The purpose of this letter is to respond and demonstrate compliance with the conditions for the approval of the following cases: 01128 01076, a Site Development Plan for Subdivision; and 01128 01077, a Site Development Plan for Building Permit. These approvals were granted at the EPC hearing on January 17, 2002.

**SITE DEVELOPMENT PLAN**

PROJECT TITLE RAINBOW BOULEVARD NW ALBUQUERQUE, NM	JOB NO. 0105	DRAWN BY SD
PROJECT MANAGER GEORGE RAINHART AA	SHEET TITLE TRACT 18 VENTANA RANCH SITE PLAN FOR SUBDIVISION

**DRAWN BY:** SD  
**JOB NO.:** 0105  
**PROJECT MANAGER:** GEORGE RAINHART, AIA  
**SHEET TITLE:** TRACT 18 VENTANA RANCH  
SITE PLAN FOR BUILDING PERMIT

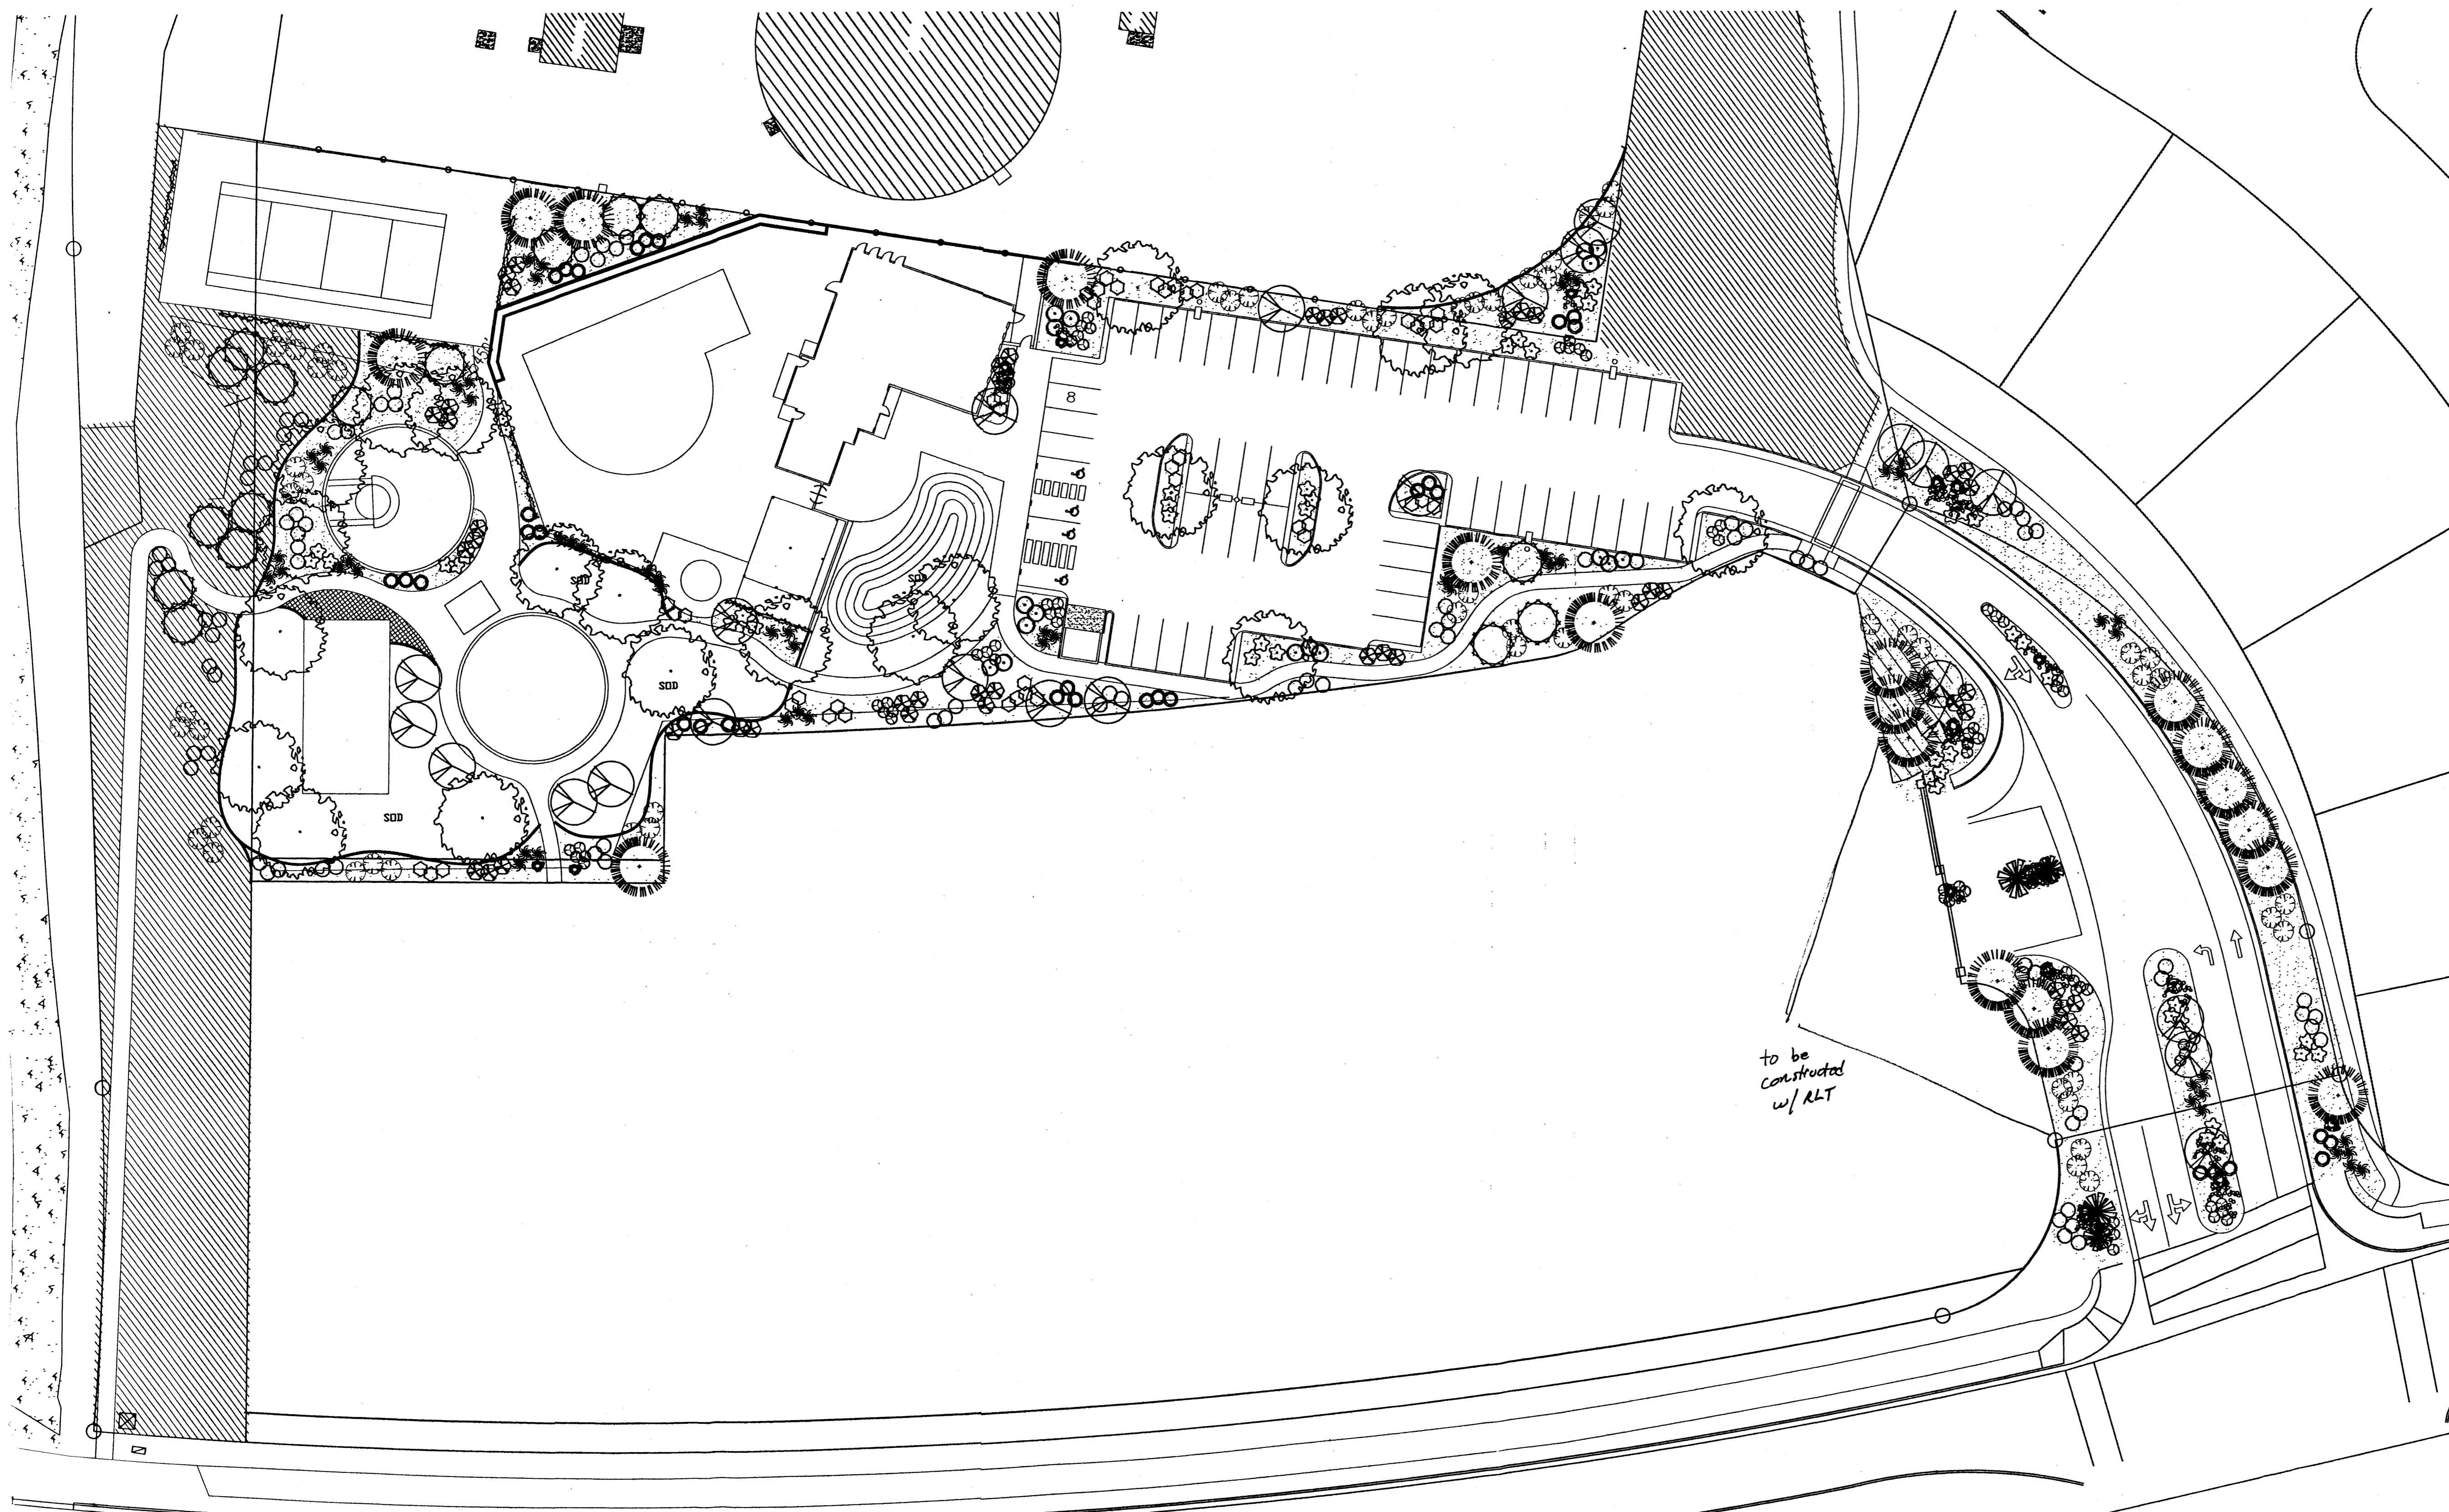
- Recreation paths outside the site shall connect to the existing recreation paths with clearly defined entries that are architecturally integrated to the building and structures on the subject site.

- Proposition: Coverings that are minimum width of 5 feet and that are clearly demarcated with highly raised or textured paving, or other slip-resistant paving materials, shall be provided where pedestrian paths cross vehicular, airports and other areas.

- Approved: These elements are provided (See Site Plan Sheet A1).
  - Shower facilities in the bathroom shall be available for disabled persons, including authorized bicycles.

- Approved: A note has been added to the Site Plan (Sheet A1).
  - All paving shall be architecturally integrated to the building and structures on the site.

- The refuse enclosure must be architecturally integrated in color and materials to the building design.
  - Approved: see detail Sheet A1.
  - Approved: signs designed for this site must be architecturally integrated to the building. Monument signs at the entry to the community center must match the building materials and colors.

- Approved: the proposed sign is shown on Sheet A1.
  - As per the Transit Department Guidelines: Over the site and the Study partners shall maintain and children who do not ride significantly more bicycle parking should be provided. Bicycle parking must be securely anchored.

- Approved: An accessibility ramped entry element has been added to enable the change from public domain to the recreation area. (See Site Plan Sheet A1)

- Approved: Pedestrian crossings have been indicated on the site plan (Sheet A1).
  - Proposition: Paving shall be perpendicular to parking stalls be provided from overlapping parking cars by permanently anchored the stucco, masonry, or masonry wall to provide for a six-foot clear pedestrian area (assume a 7' parking stall).

- Approved: Shower facilities shall be clearly demarcated for convenient pedestrian access to encourage non-vehicular travel and shared vehicle travel to the community center.

- Approved: see paving and roof details Sheet A1.
  - All recreation equipment, including wireless facilities, shall be screened from view from the adjacent residential areas and the recreation area. (Warning: Recreational equipment shall be located below the top of the ground and screened from view from the property line of the site. All ground-mounted equipment shall be screened with screen walls up the top of the equipment below the top of the screen wall.)

- Approved: a note has been added to the Site Plan stating that additional securely anchored temporary bicycle parking will be provided by the applicant during the building process.
